HOMOLOGATION AND TECHNICAL SPECIFICATION UPDATE BULLETIN

HOMOLOGATION	Rotax 125 Senior Max	HOMOLOGATION NO.	113H
BULLETIN NO.	Rotax 20	BULLETIN DATE	9 December 2016
SUBJECT	Support Plate System for Senior Max Ignition Coil

Support Plate System for Rotax 125 Senior MAX

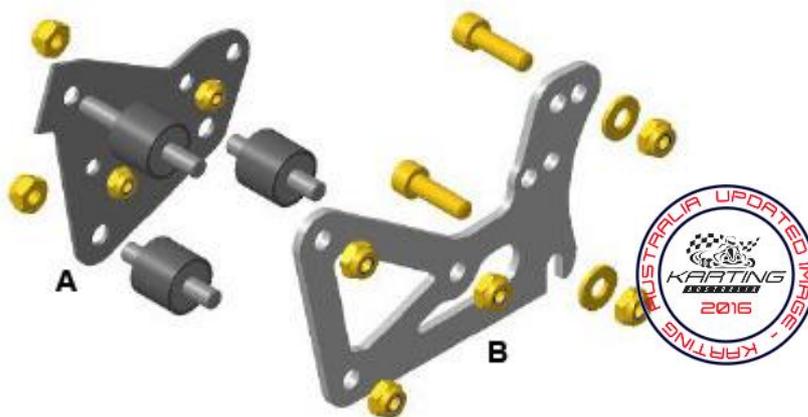
The new support plate system for mounting the ignition coil and magnet valve is a more compact system with less electrical connections at the backside of the engine, and the ECU now located in the battery housing. This system creates less risk of interference from any chassis components.

(A) Mounting Plate (Part No. 651 925)

(B) Retaining Plate (Part No. 651 935)
